Project	Gloucester Coal Seam Gas Project	From	Michael Ulph
Subject	Community Consultative Committee	Tel	4941 2841
Venue/Date/Time	Thursday 2 April Gloucester Country Club, 10am – 1pm	Job No	21/17714
Copies to	All attendees		
Attendees	Ian Shaw – AGL Lands Officer Toni Laurie – AGL Land and Approvals Manager Naomi Rowe – AGL Community Relations Manager Dr. Richard Evans – Independent Peer Reviewer, Principal Hydrogeologist (SKM) Ray Dawes - BGSPA Ed Robinson – Lower Waukivory Residents Group Gerald McCalden – The Gloucester Project Rod Williams – Community Representative Anna Kaliska – Mid Coast Water Clr Paul Hogan – Mid Coast Water David Mitchell – Avon Valley Landcare Clr Jerry Germon – Gloucester Shire Council Graham Gardner – Gloucester Shire Council Clr Tony McKenzie – Dungog Council Tim Hickman – Community representative Michael Ulph – GHD (Facilitator) Lilen Pautasso – GHD (Assistant Facilitator) Tim Weeks – Gloucester Shire Council (Observer)	Apologies	<b>Karen Hutchinson</b> <b>Lisa Schiff</b> <b>Terry Kavanagh</b>

Item	Action
<b>1. Introduction</b> <i>Welcome and Acknowledgement of Country</i>	
<b>2. Meeting agenda</b>	
▶ Introduction and welcome to new attendees	
▶ Disc

### Conceptual Model – Coverage of model

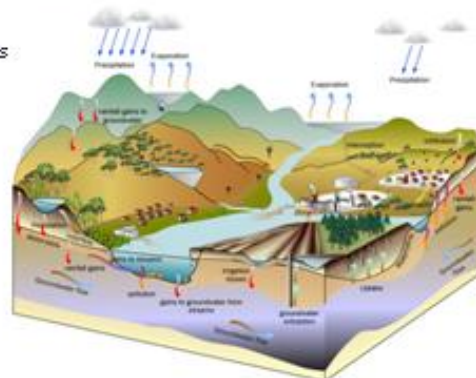
Rick: The conceptual model only covers a very small part of what is 'stage 1'. They don't extend far enough and my understanding is that there is probably enough existing data which would allow someone to extend their special coverage up, down and across the value much more. The PB report also only looks at 200-300m whereas most of the action is between 200-1000m. The fact that we don't have any deeper data is a concern. The model is a bit too limited at the moment and that needs to be addressed.

- > Apparent that the conceptual model is:
  - o Spatially limited – cross sections represent only a small part of Stage 1 GFDA and area that would be covered by a numerical model. Can be expanded by using existing data and by new drilling.
  - o Vertically limited – conceptual model developed in PB (2012) strongly focussed on upper 200-300m. Further description required on units at depth

## Conceptual Model Water Balance

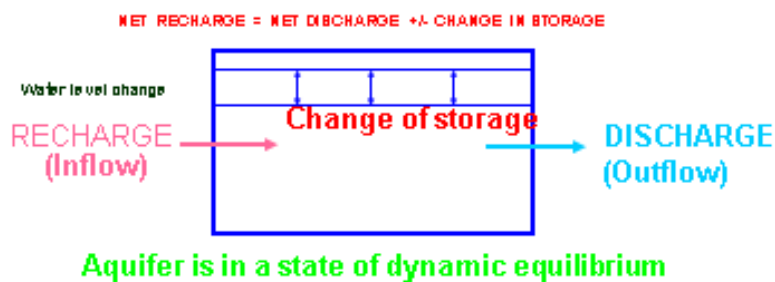
Rick: Water balance is simply where, at the conceptual model stage, you define in quantitative terms the actual major flow processes occurring. The current guidelines that exist state that at the conceptual

model stage, one needs to do a water balance. I suggest that it is done at three stages (pre, maximum and post development). Effectively 3 water balances.

Rick: Yes. That's right. What I'm trying to do is to set the scene on what the fundamental aspects are. The water balance allows you to see what the scales of the potential impacts are and highlights uncertainty. I'm pushing the PB people to do more conceptual thinking at this stage. There has been no attempt to put any numbers on these events yet, however rough they are at the conceptual model stage.

**Characterisation of vertical hydraulic conductivity (1)**

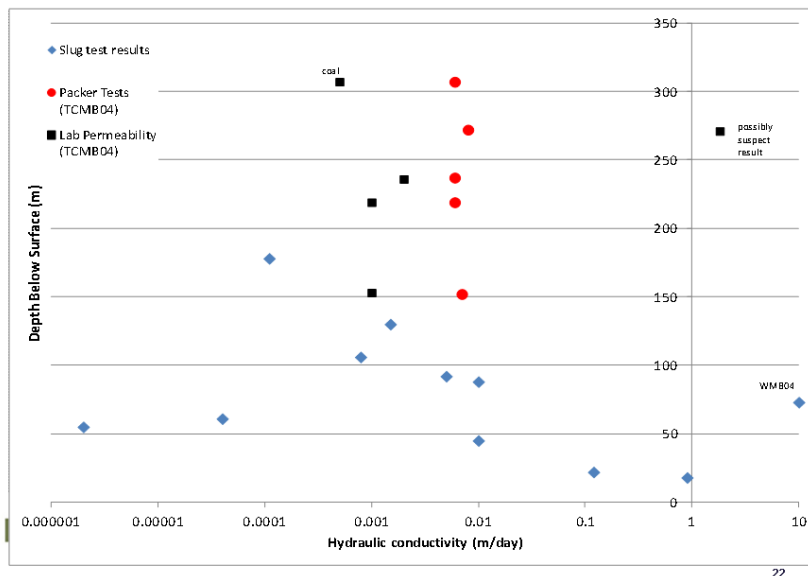
- > Reports currently don't address distinction between vertical ( $K_v$ ) and horizontal ( $K_h$ ) hydraulic conductivity
- > Most results are  $K_h$ , what  $K_v$  values will be used in model? (model results likely to be sensitive to  $K_v$ )
- > Range in results for 4 units is large – what will be used in the model?
- > How will differences in results between slug tests and packertesting / lab testing be handled?

Rick: It is normal for large variations in the slug test, but what is causing the extremity results (e.g. 10, 0.000001) need to be explained in the report. Normally a conceptual model would discuss how this is going to be used and the distinction between the results needs to be made.

Rick: The 'possibly suspect result' is, in my opinion, absolutely normal because there are many factors that may have impacted on this (e.g. a spoiled sample). I wouldn't be concerned about this or draw any

**Slide 1: Characterisation of GDEs**

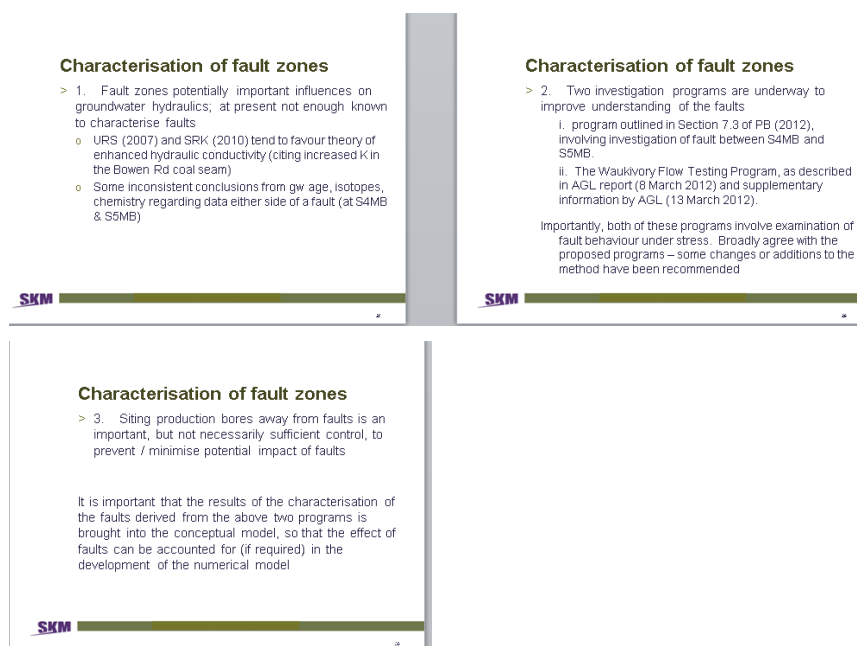
- > **Baseflow GDEs**
  - o Baseflow assessment is recommended to determine baseflow contribution (will require gauging of at least one of the new stream gauges)
  - o Can't assume it is small based on visual inspection or not important based on salinity
  - o Difference in salinity between alluvial groundwater and baseflow should be investigated. Relates to important question of proportion of flow that is gw
  - o Given conceptual understanding of discharge (to north of study area), a baseflow assessment at stream gauge GS20028 is recommended and also the next gauge downstream.

- > **Springs**
  - o Some reference to monitoring of 'at least one spring' in the Alum Mountain Volcanic formation
  - o No other discussion on number, use, importance etc of these springs
- > **Terrestrial vegetation**
  - o There is potential for ET wherever gw is shallow.
  - o Unlikely to be a relationship of high dependence (given generally brackish nature of gw and consistent nature of rainfall)

- > Approach/rationale behind development of monitoring infrastructure not clearly described
- > Description of Stage 1 GFDA development would assist in this regard
- > Needs to be a feedback loop between process of modelling impacts and design of monitoring network

**Characterisation of fault zones**

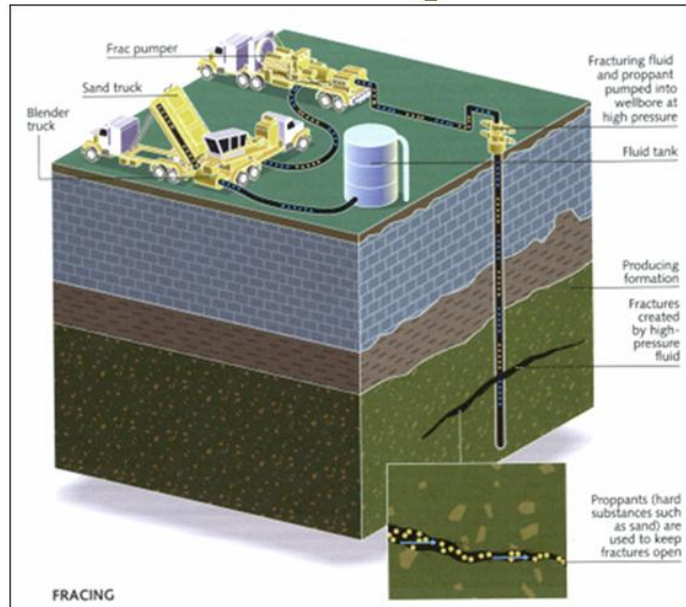
- > 1. Fault zones potentially important influences on groundwater hydraulics, at present not enough known to characterise faults
  - o URS (2007) and SRK (2010) tend to favour theory of enhanced hydraulic conductivity (citing increased K in the Bowen Rd coal seam)
  - o Some inconsistent conclusions from gw age, isotopes, chemistry regarding data either side of a fault (at S4MB & S5MB)

- > 2. Two investigation programs are underway to improve understanding of the faults
  - i. program outlined in Section 7.3 of PB (2012), involving investigation of fault between S4MB and S5MB
  - ii. The Waukvory Flow Testing Program, as described in AGL report (8 March 2012) and supplementary information by AGL (13 March 2012).

- > 3. Siting production bores away from faults is an important, but not necessarily sufficient control, to prevent / minimise potential impact of faults

It is important that the results of the characterisation of the faults derived from the above two programs is brought into the conceptual model, so that the effect of faults can be accounted for (if required) in the development of the numerical model
